Date: December 18, 2003  
 To: T10 Committee (SCSI)  
 From: Jim Coomes (Seagate)  
 Subject: SBC, SPC, Obsolete Third Party XOR Commands

This is a proposal to obsolete the third party XOR commands.

**Figure 0.1 — Update write operation (third-party)**

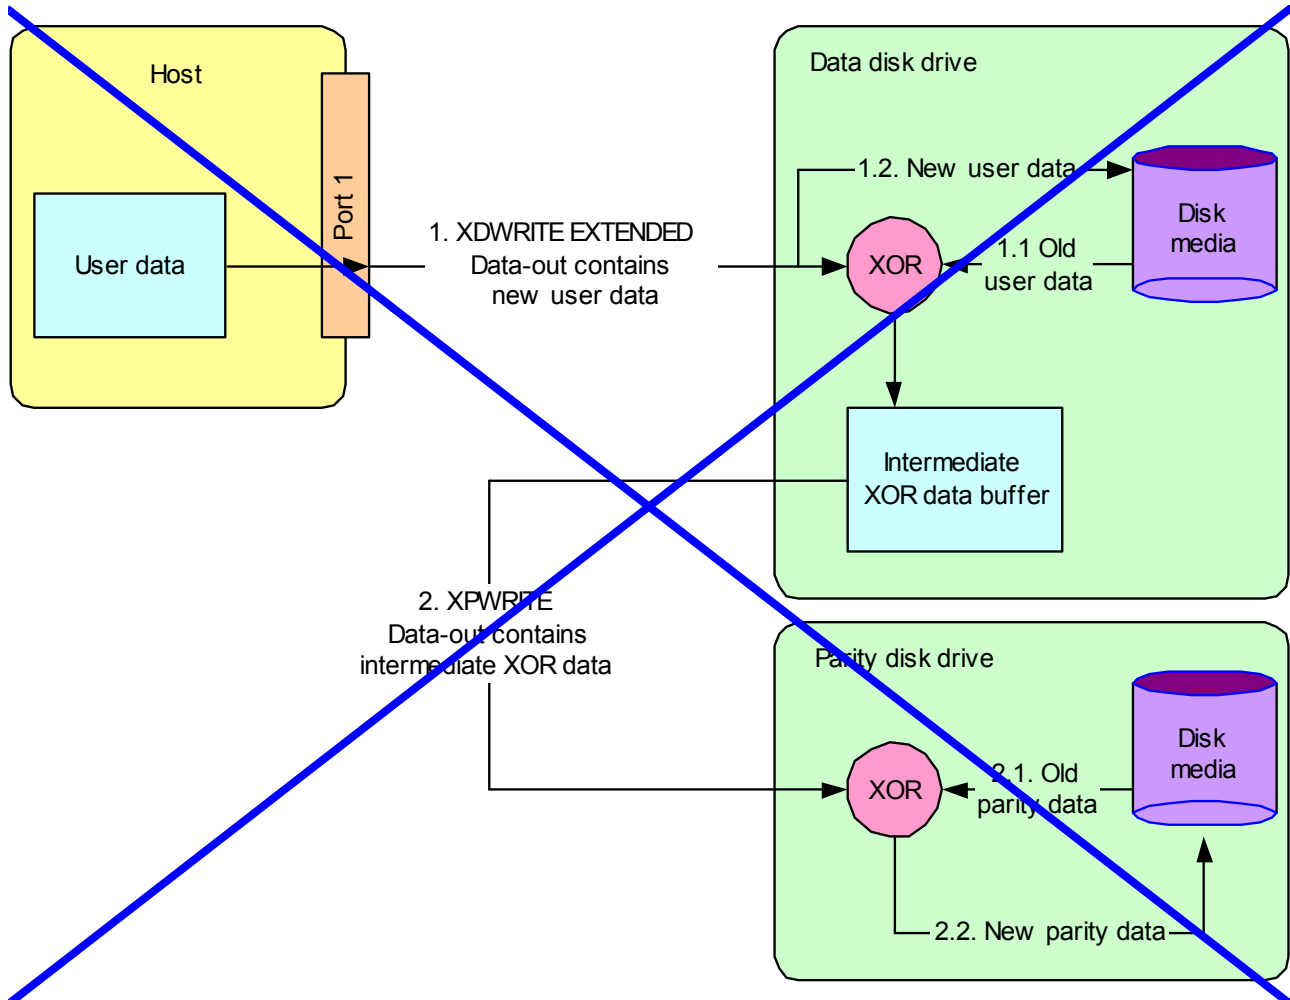
~~Figure 0.1 illustrates a third party read modify write operation. The example uses a host, a data disk device (holding protected user data), and a parity disk device (holding check data). In this example, the data and parity devices are on the same SCSI physical interconnect, and thus are capable of peer to peer interaction. Two SCSI commands are used: XDWRITE EXTENDED and XPWRITE.~~
